**DEVELOPMENT REVIEW BOARD MEETING**

**2. Resolution No. 406 Frog Pond Terrace**

DB22-0003 Frog Pond Terrace

**DEVELOPMENT REVIEW BOARD  
RESOLUTION NO. 406**

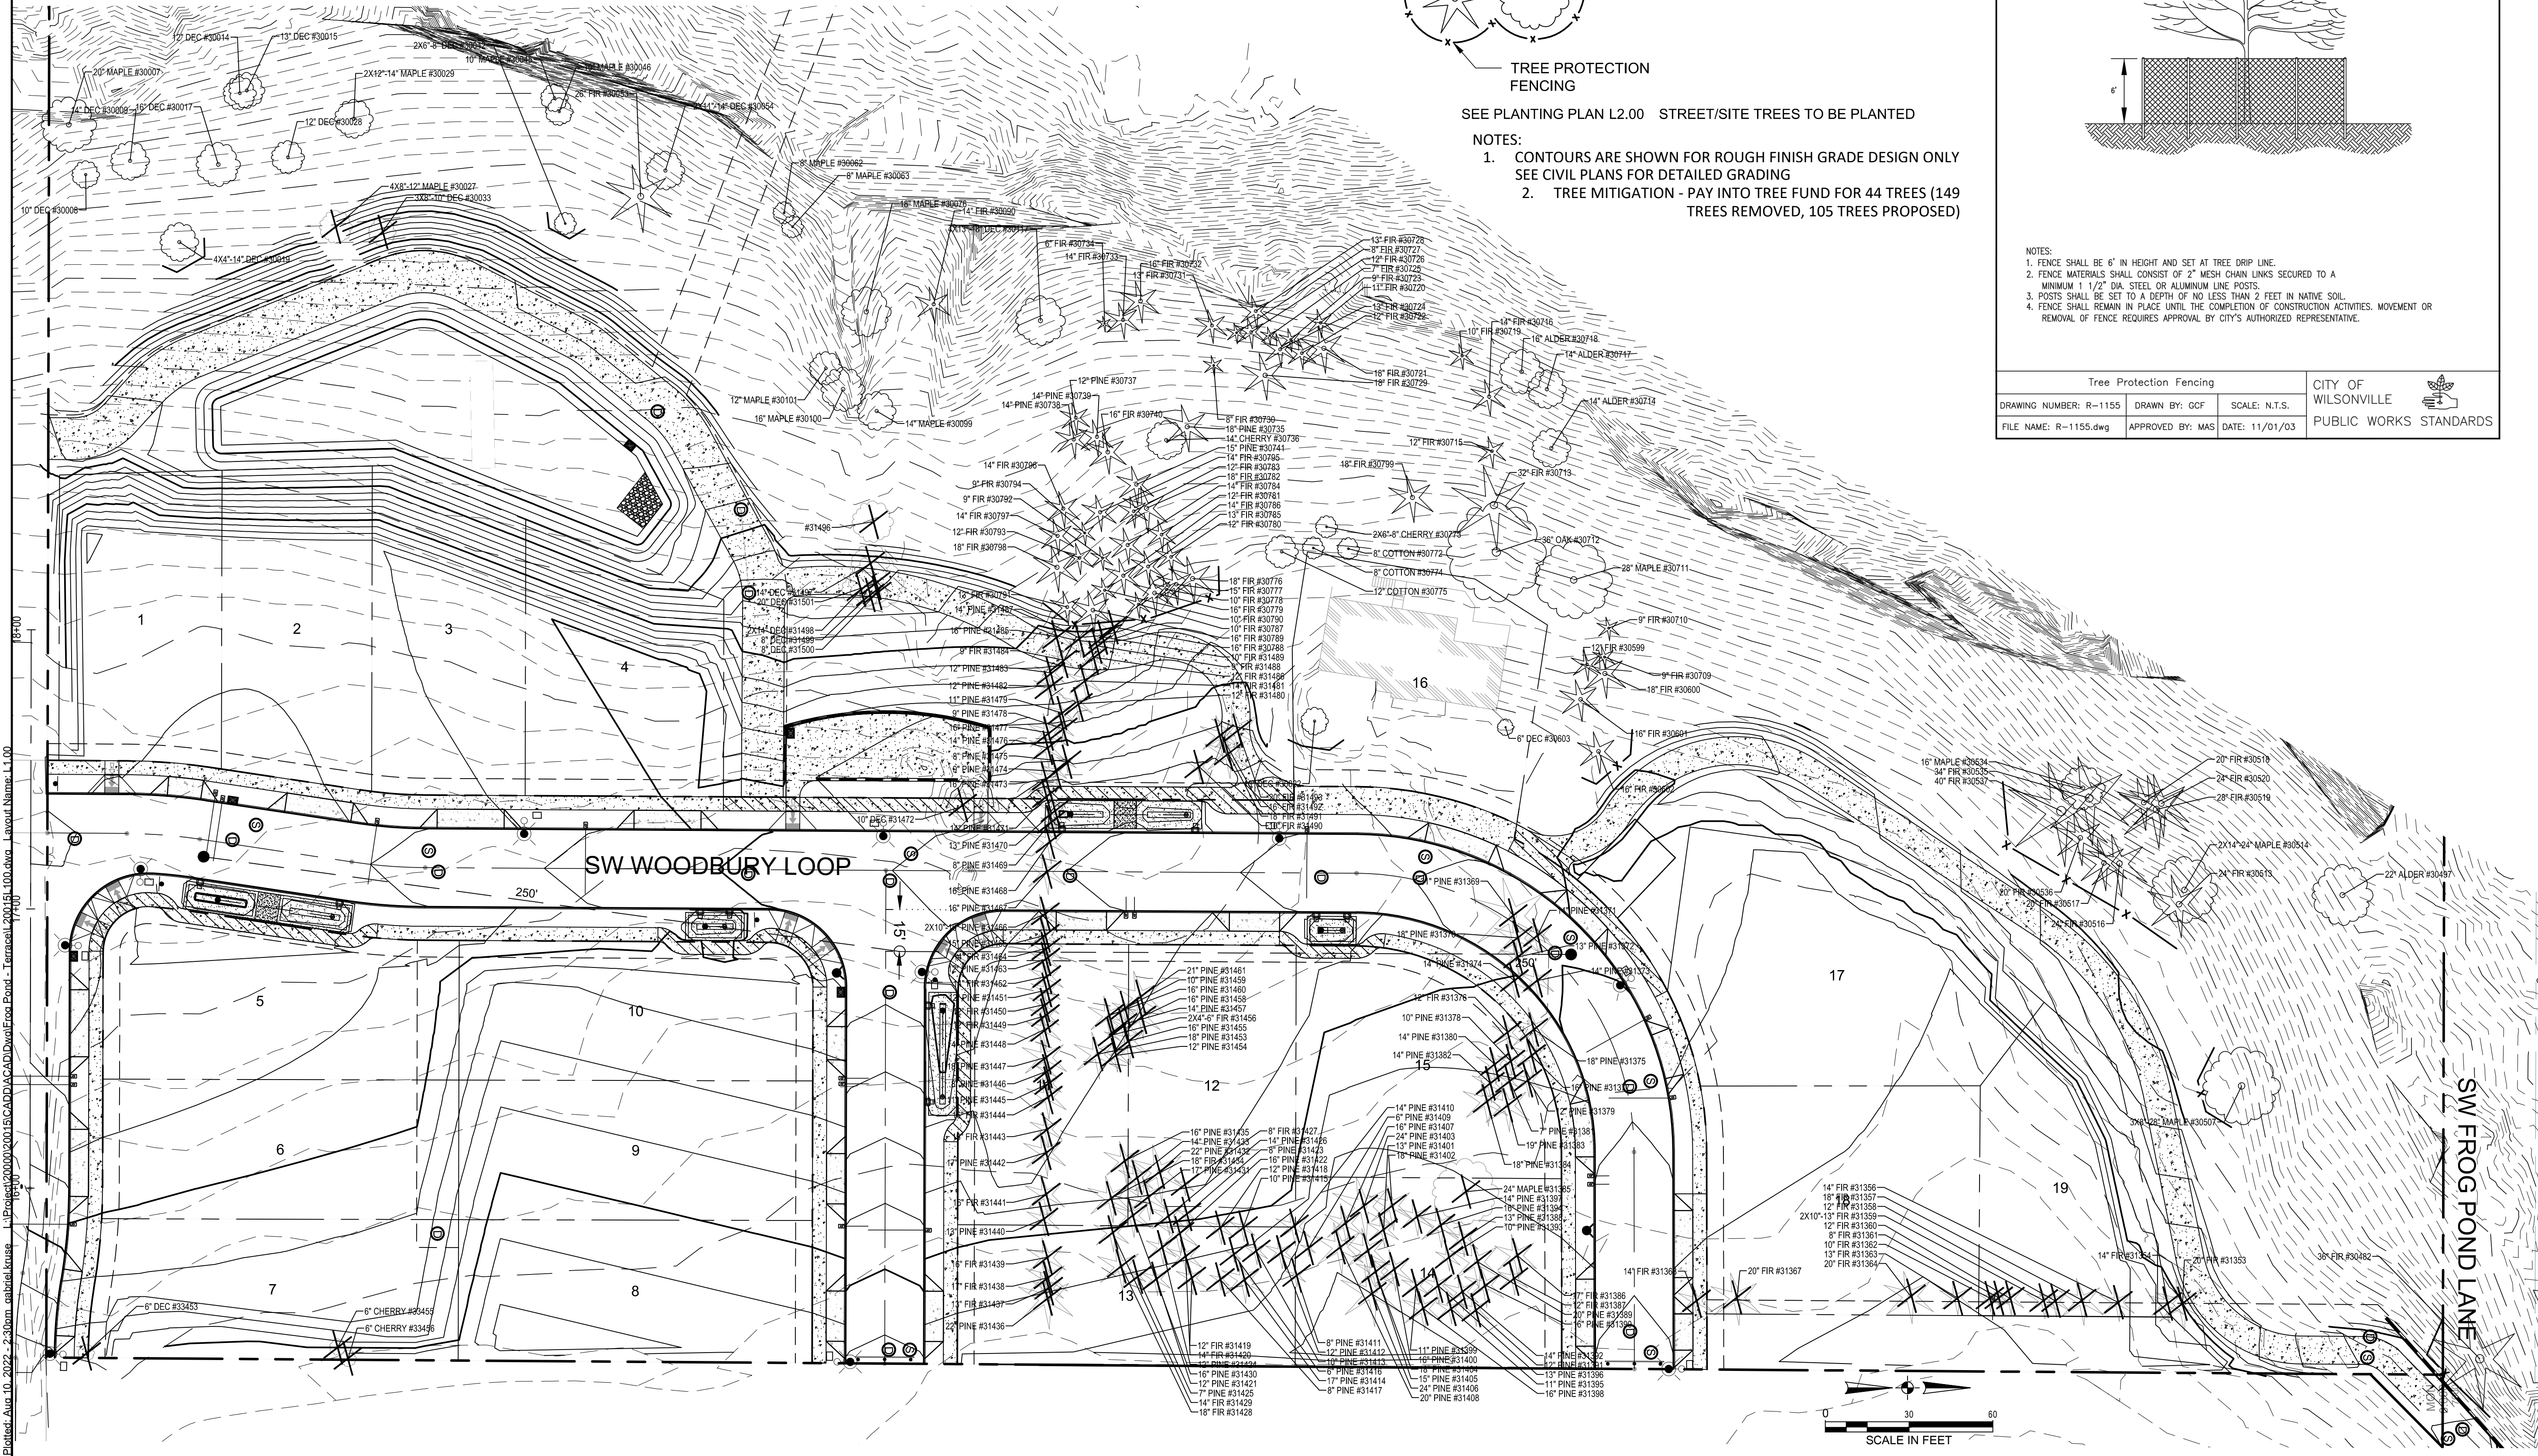
*How many mitigation trees will be planted – as street trees, in Tract A, etc. – on-site?*

**Response:** See Sheets L2.00 and L2.20.

- 30 Street Trees
- 41 Site Trees
- 34 Tract A Stormwater Planting Trees
- 105 Total Mitigation Trees
